Docket Number:	08-AFC-08A
Project Title:	Hydrogen Energy Center Application for Certification Amendment
TN #:	200144
Document Title:	Responses to PSA/DEIS Information Requests, Set 1
Description:	N/A
Filer:	URS
Organization:	URS Corporation
Submitter Role:	Applicant's Consultant
Submission Date:	8/9/2013 2:39:19 PM
Docketed Date:	8/9/2013

Responses to PSA/DEIS Information Requests, Set 1

Amended Application for Certification for HYDROGEN ENERGY CALIFORNIA (08-AFC-8A) Kern County, California

FIGURE CS-7-1

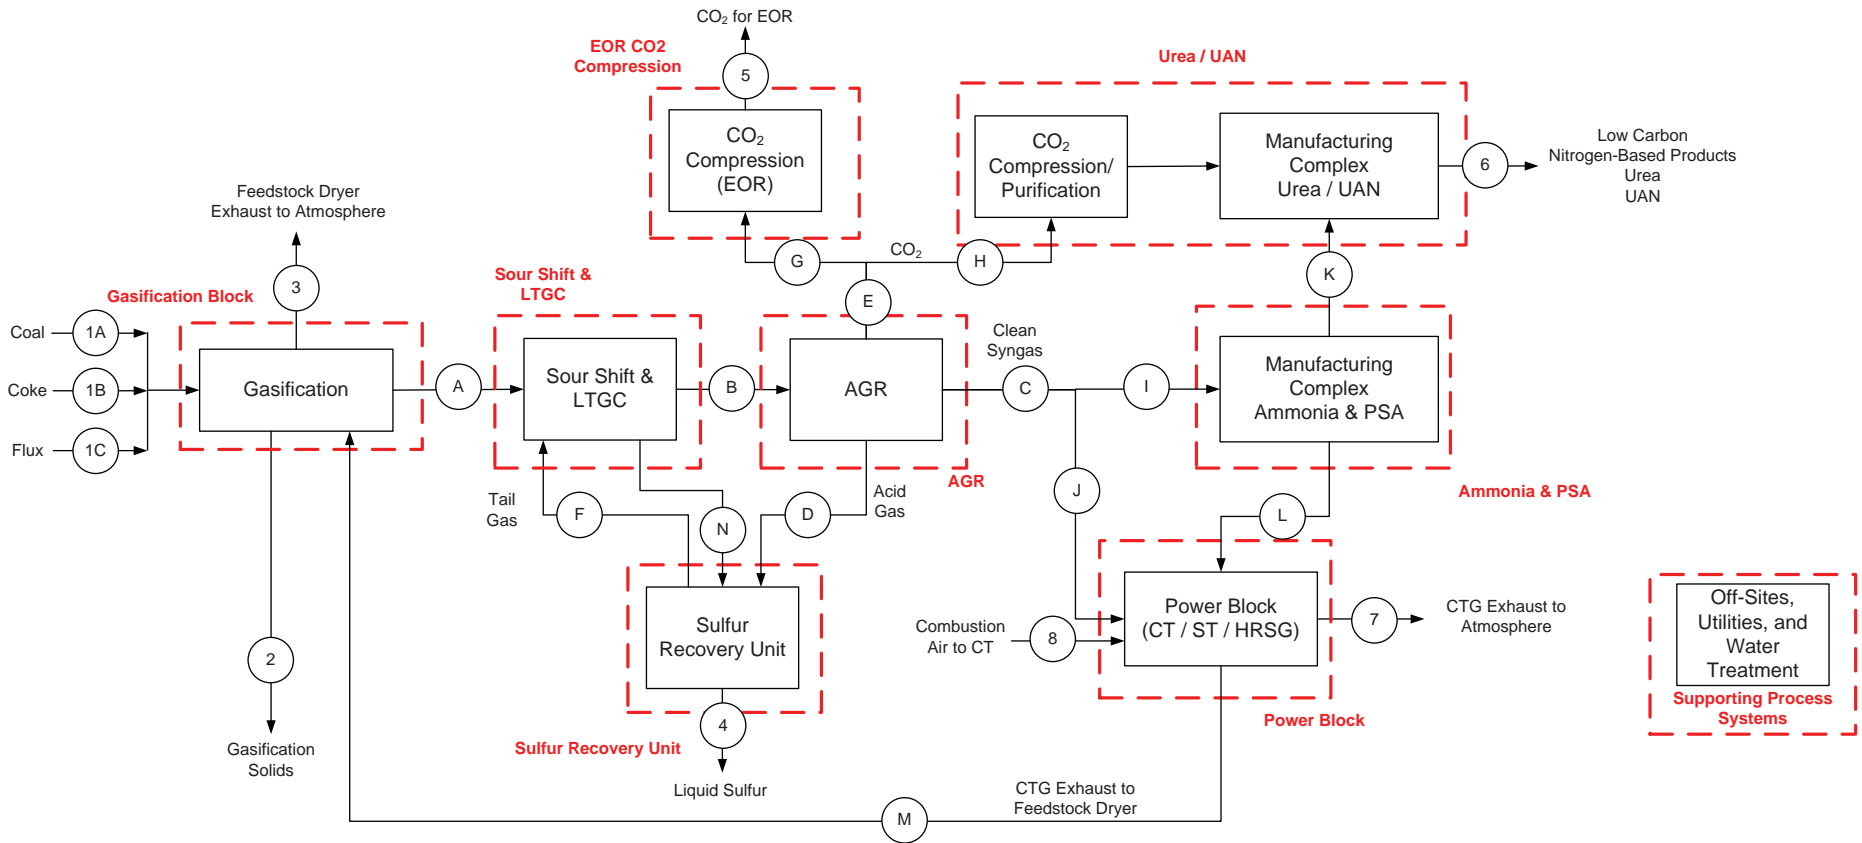
CS-7A. Please provide a carbon balance for HECA demonstrating the complete flow of carbon from the introduction of feedstock to the coal dryer to the products (including carbon dioxide [CO₂]) and waste streams. Please provide this carbon balance for both the On- and Off-Peak operating cases. This carbon balance should be more detailed than what was previously provided in the Amended AFC and data responses, clearly identifying the carbon in all the streams between major processes and process units where carbon flows change.

Figures CS-7-1 and CS-7-2 show the updated carbon balance flow diagrams for the on-peak and off-peak cases. These show the internal carbon flows between each major unit grouping during steady state operation. The on-peak operation will occur approximately 16 hours per day, and represents peak power generation with reduced fertilizer production. The off-peak operation represents off-peak, or reduced, power generation with maximum fertilizer production.

FIGURE CS-7-3

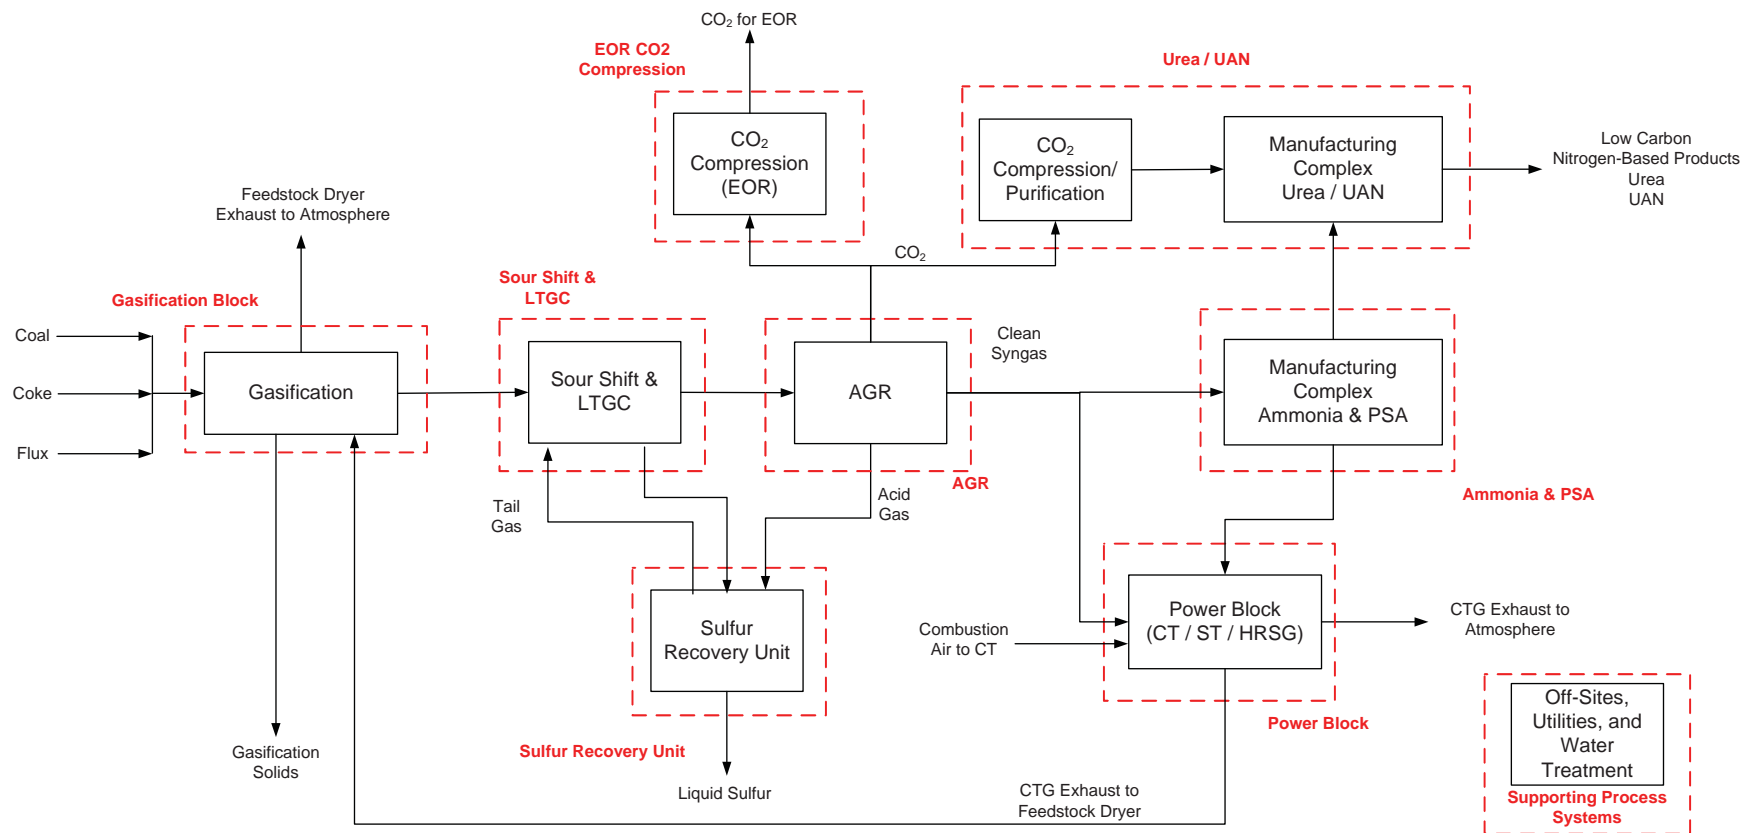
CS-2. A complete electrical energy balance estimate for HECA that includes the complete gross electrical production and complete parasitic load for the plant by major functional area, including the air separation unit, in MWh for both hydrogen rich fuel and natural gas operation. Staff cannot complete its determination of compliance with the SB 1368 EPS without this information.

CS-7B. Please provide detailed background information supporting the latest applicant-sponsored SB 1368 calculations. Please provide the following:

Much of this information can be found in the response to Information Request CS-7. An electrical energy balance by major functional area is presented in Figure CS-7-3, On-Peak and Off-Peak Block Flow Diagram of Auxiliary Loads. Parasitic load from the ASU in On-Peak and Off-Peak operation is presented in Table CS-7-4, ASU Auxiliary Loads. Net power output (MWh) for early, mature, and steady-state syngas operations is presented in Table CS-7-3, SB1368 Emission Performance Standard.

Figure CS-7-3 presents a block flow diagram of the auxiliary loads at HECA for both on-peak and off-peak operation. The following units are associated with the production of syngas and are considered common: Gasification, Sour Shift & LTCC, AGR, Sulfur Recovery unit, and EOR CO₂ compression. The PSA/Ammonia and Urea/UAN units are associated solely with the fertilizer complex, and the power block is associated with power. The power consumption of the common units is allocated according to the syngas usage of the power and fertilizer units. During On-Peak operation, 71.3 percent of the syngas is used by the power block and 28.7 percent of the syngas is used by the fertilizer complex. During Off-Peak operation, 52.1 percent of the syngas is used by the power block and 47.9 percent of the syngas is used by the fertilizer complex.

The fertilizer power generation values were revised during design refinement. These updated values are presented in Figure CS-7-3.

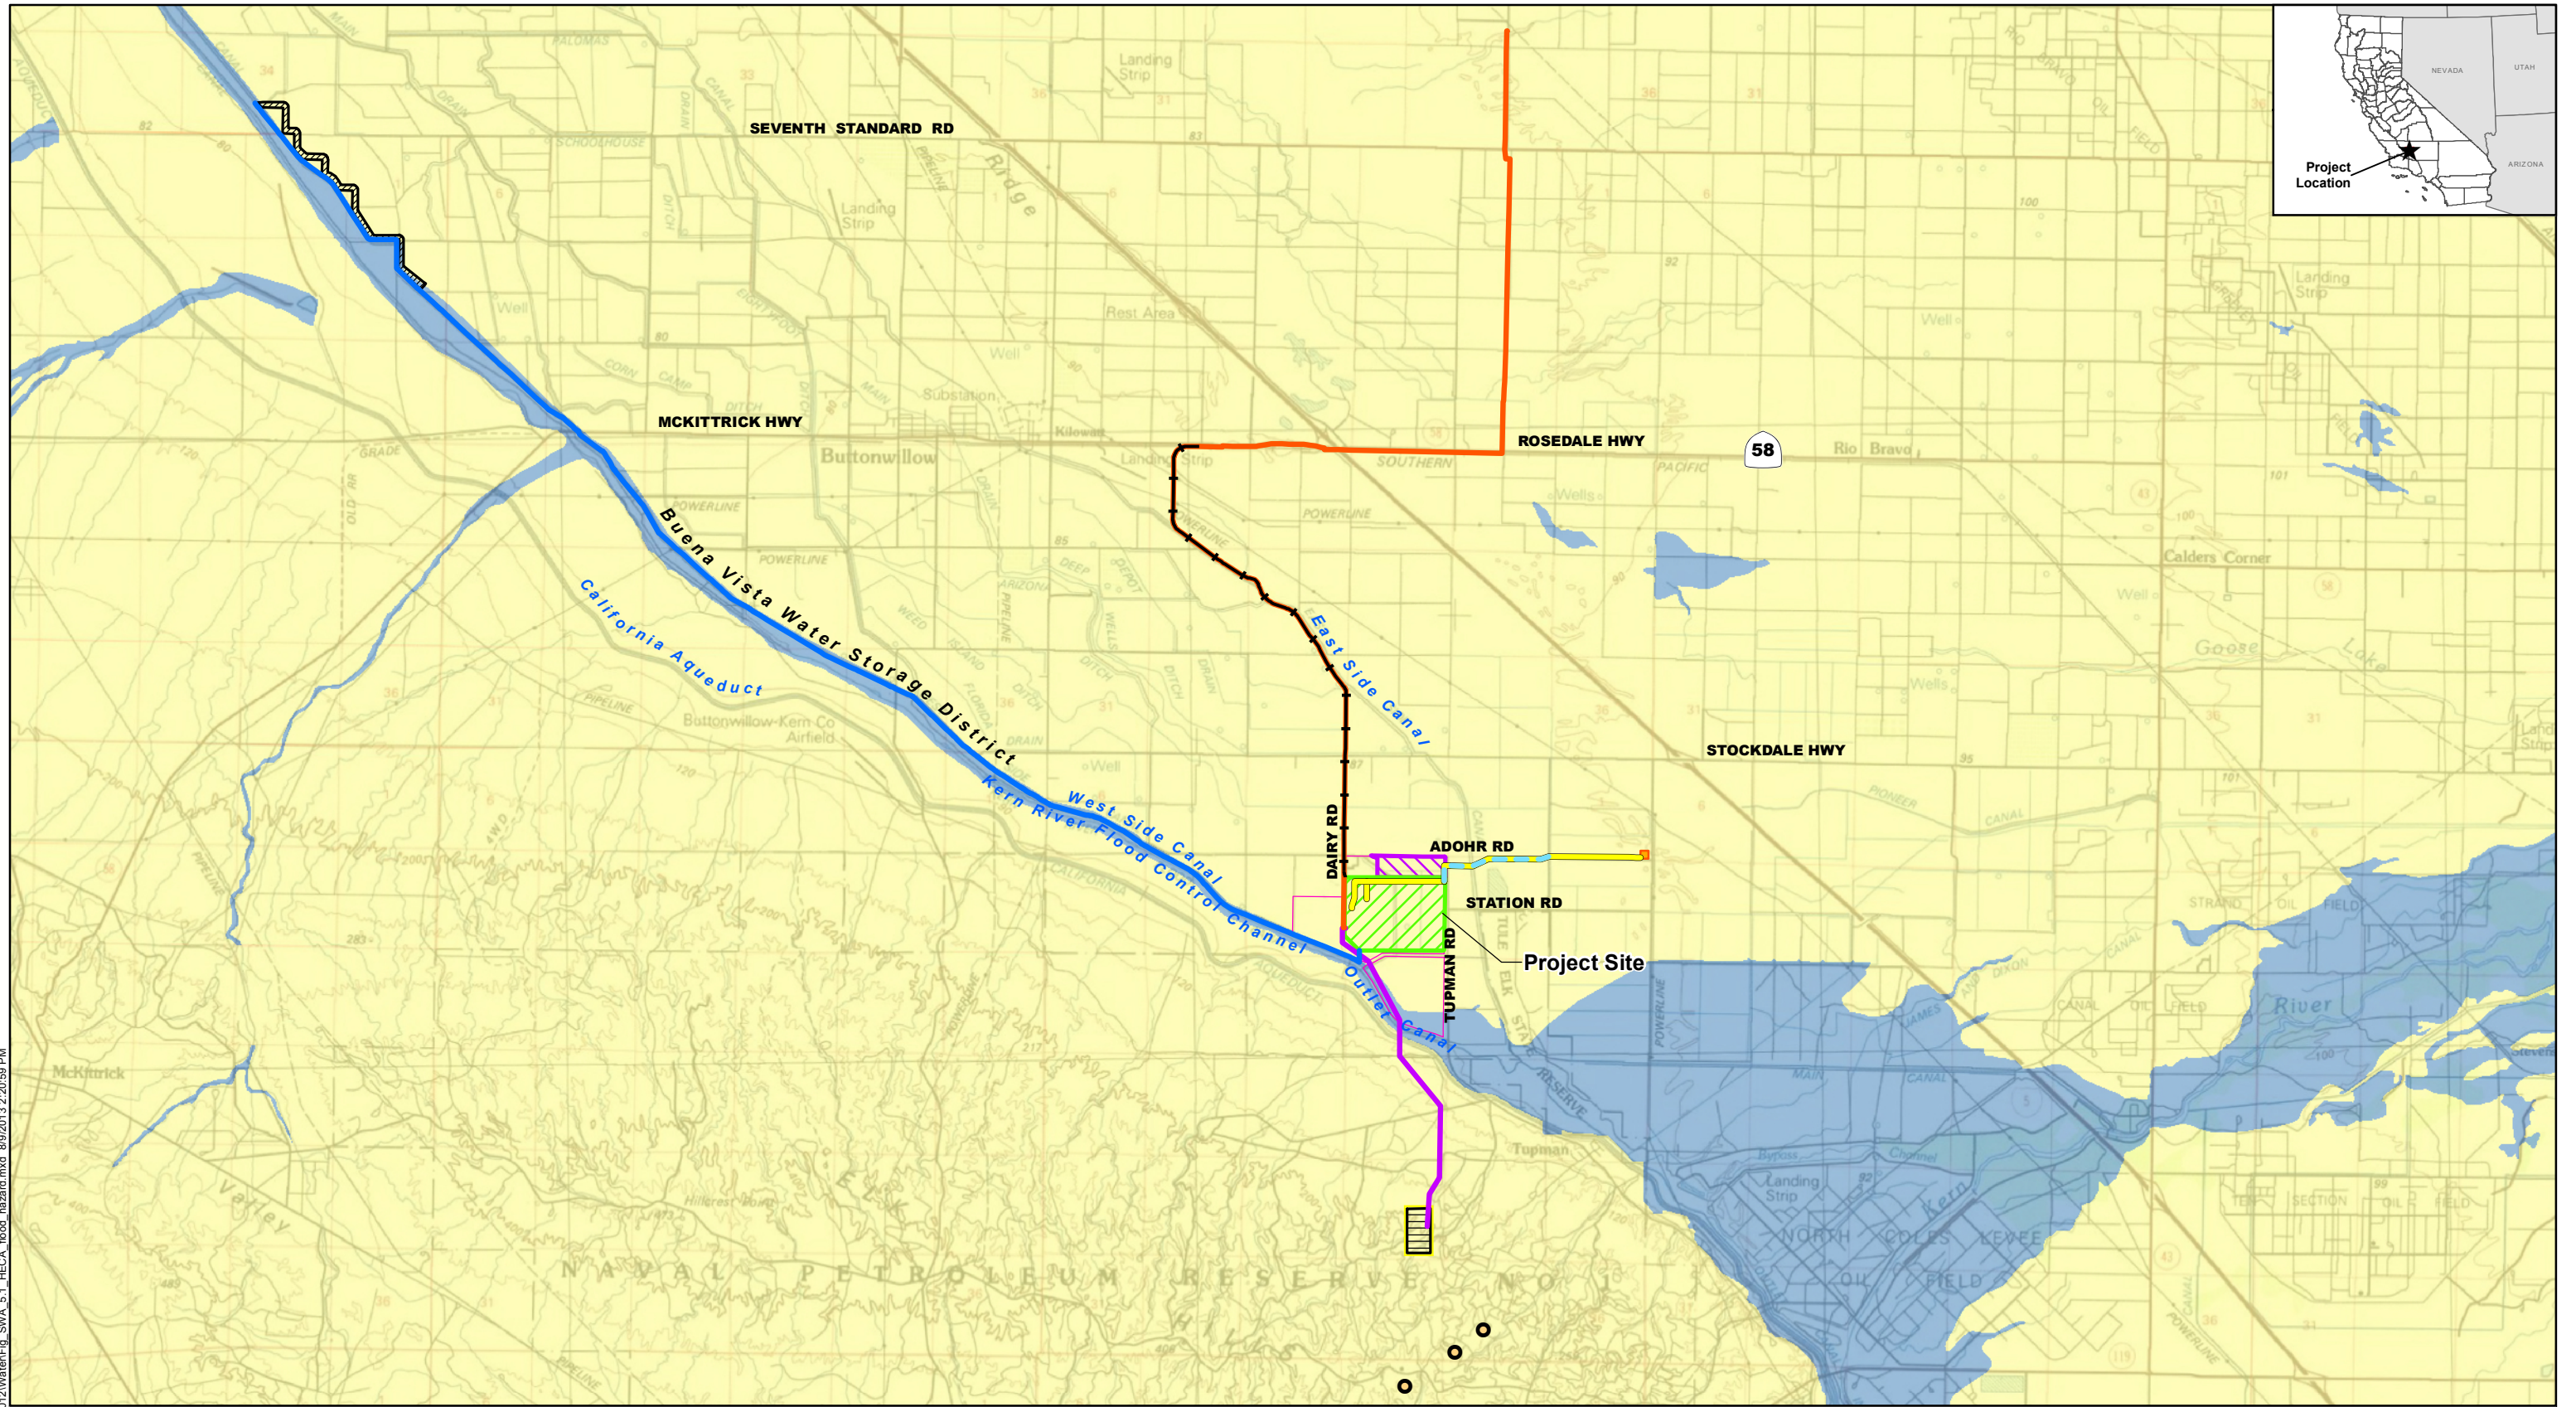
SSW-4. Description of typical methods proposed for accommodating flows under or around the rail bed. Include maps that show locations of drainage features and indicate what flows they would be designed to handle.

The construction of the railroad spur would require a bridge crossing over the East Side Canal. Construction of a bridge would require the installation of permanent concrete or steel abutments and support structures. Although the installation of the railroad bridge would result in permanent fill in the bed and banks of the canal, the canal is an engineered irrigation conveyance facility that is intensively managed. The final design of the crossing has not been established, but may include support piles in the canal. The bridge would be designed to maintain the hydraulic conveyance capacity of the existing canal. Aside from the site of the railroad bridge, all of the potential impacts to the East Side Canal would be temporary, and the bed and banks would be restored following construction. The bridge across the East Side Canal would be constructed when the canal is dry to minimize or avoid potential impacts to water conveyance or water quality.

FIGURE TRA-1

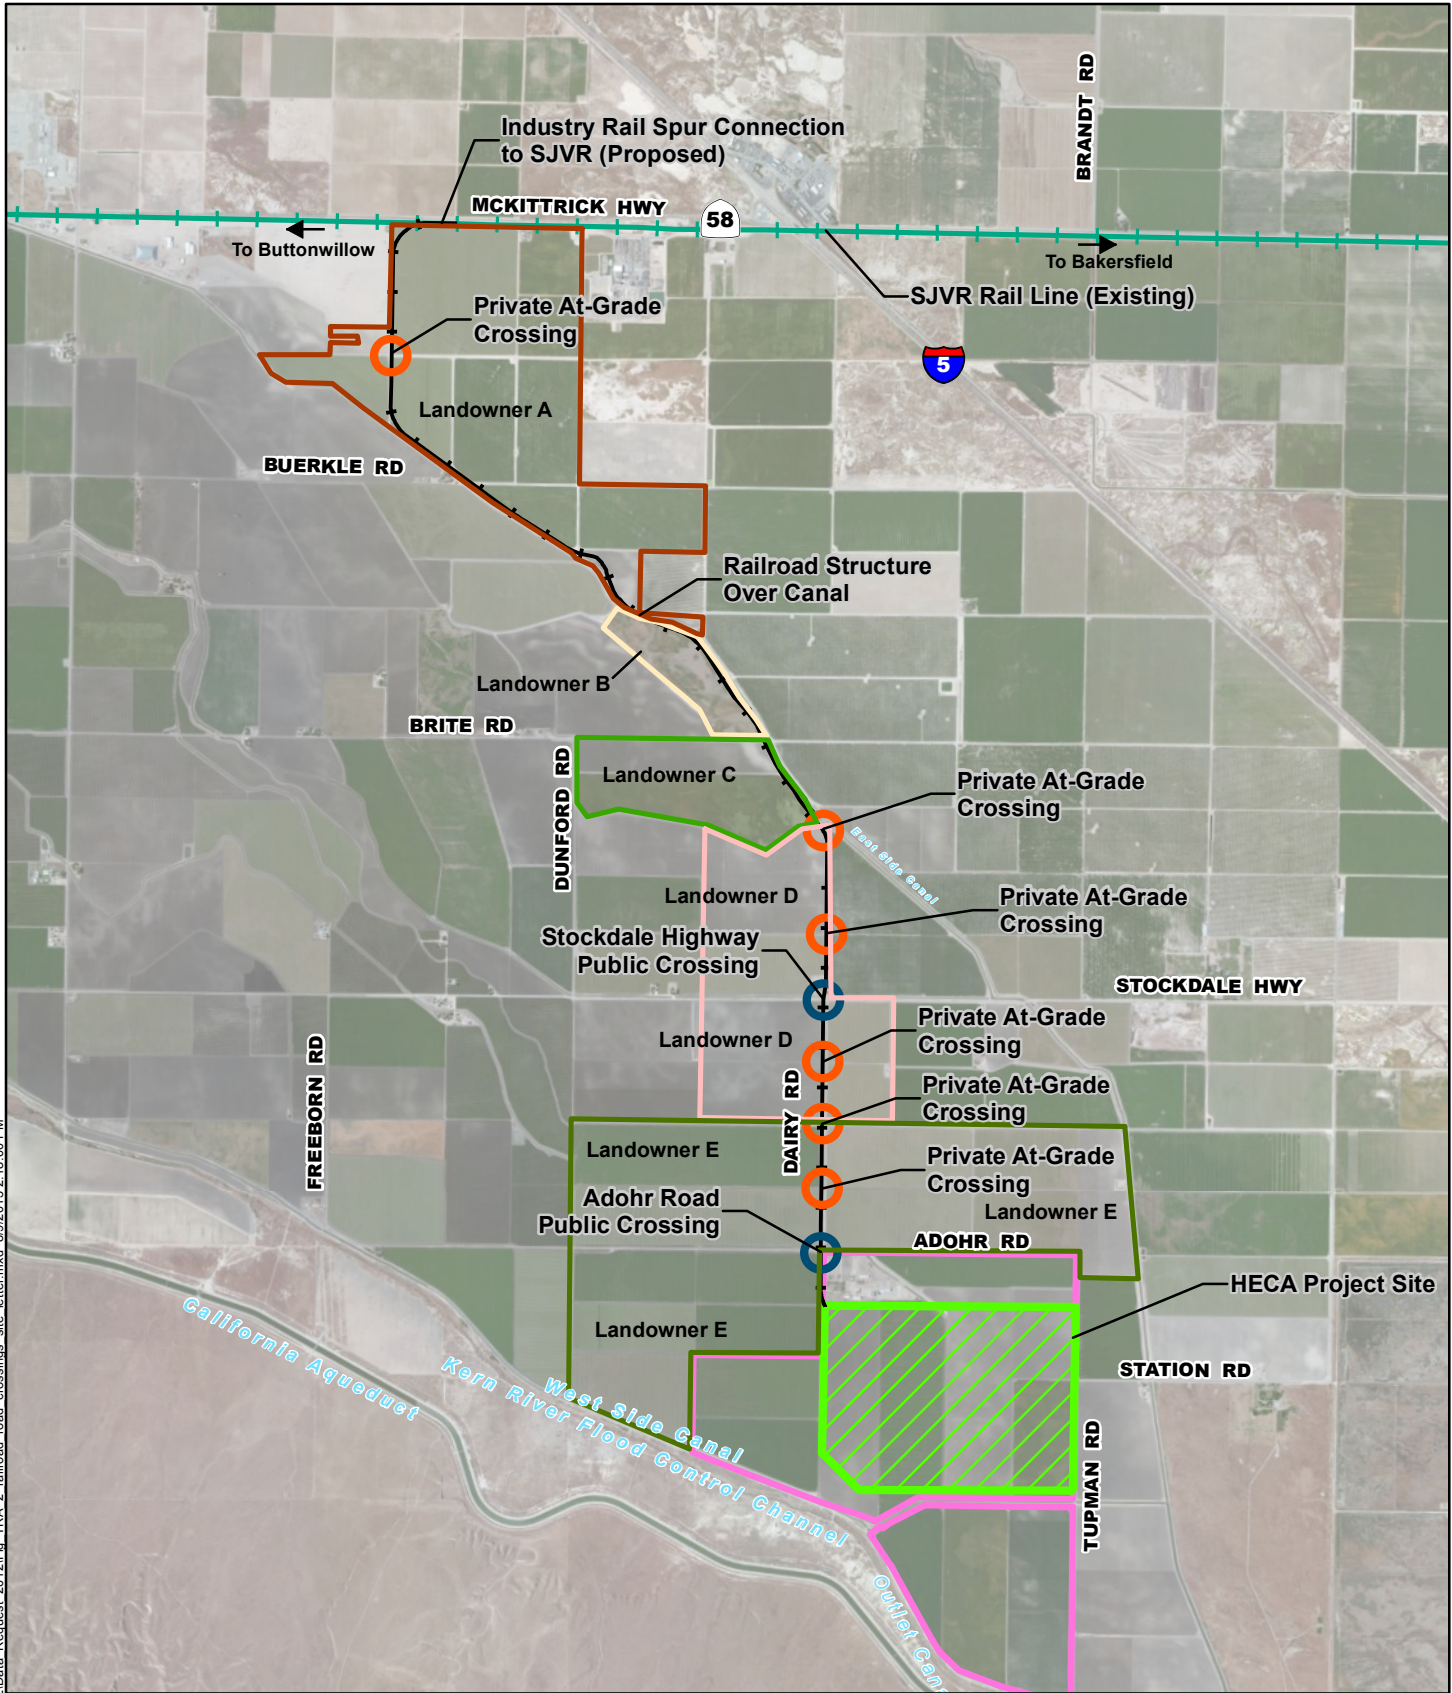
TRA-2. Staff has raised a question regarding the need to expand the Wasco coal servicing facility to serve the project's demand. Potential components of the coal servicing facility initially considered by staff include the possible need for additional storage silos and/or receiving lane for trains and/or haul trucks. Staff requests the applicant identify specific components that would need to be expanded at the coal servicing facility in Wasco. The project's potential demand for expanding the Wasco coal servicing facility will be addressed in the FSA.

The rail spur would require private at-grade crossings. Warning devices for all of the proposed private at-grade crossings would consist of CPUC standard No. 1X private crossing signs (see Figure TRA-1).
